Amendments to the Drawings

REMARKS

The preceding amendments and following remarks are submitted in response to the Final Office Action mailed November 9, 2005, setting a three month shortened statutory response ending February 9, 2006. With this Amendment, claims 29 and 33 have been amended and claims 34-39 have been added. Claim 25 was previously cancelled. Claims 1-24 and 26-39 remain pending in this application. Reconsideration, examination and allowance of all pending claims are respectfully requested.

Figure 2

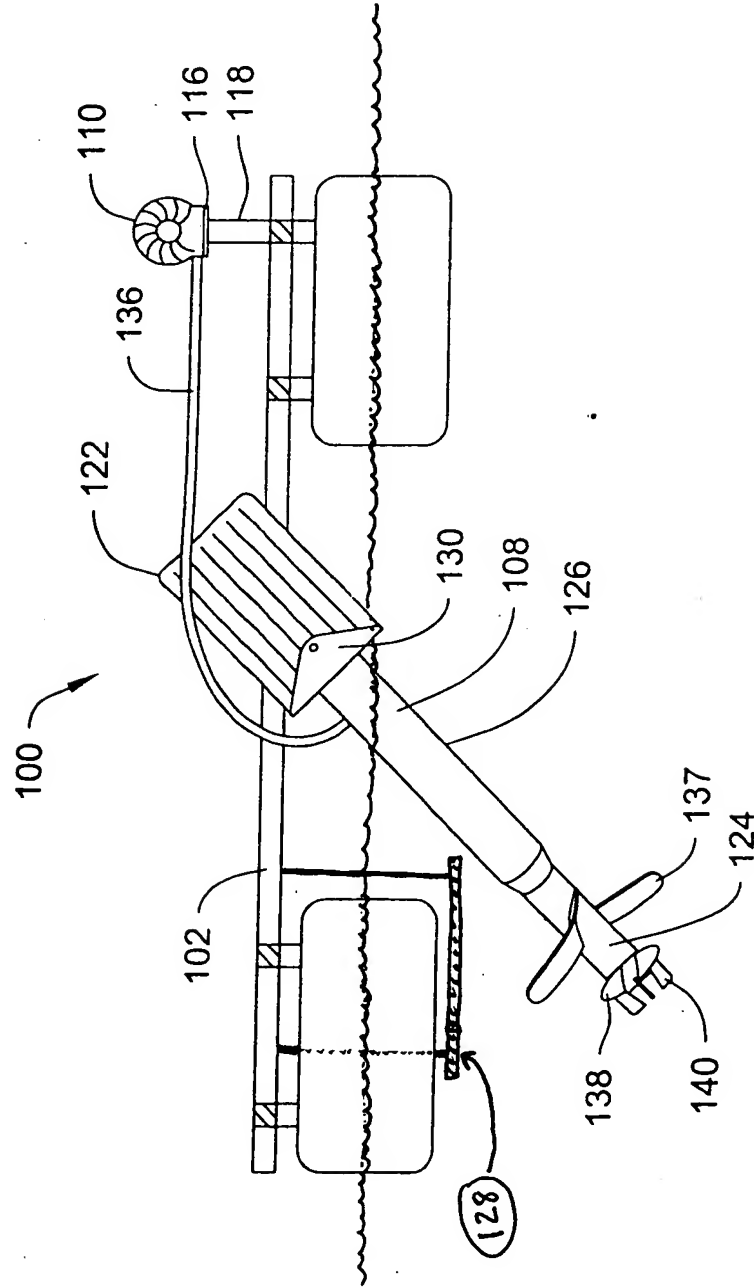
Applicants have amended Figure 2 in order to more clearly show one of the embodiments of the Application. Specifically, the vortex plate is shown in Figure 2, along with showing the approximate water line in relation to the vortex plate. Support for this amendment to the drawings can be found, for example, at page 6, lines 9-17 of the Application as originally filed.
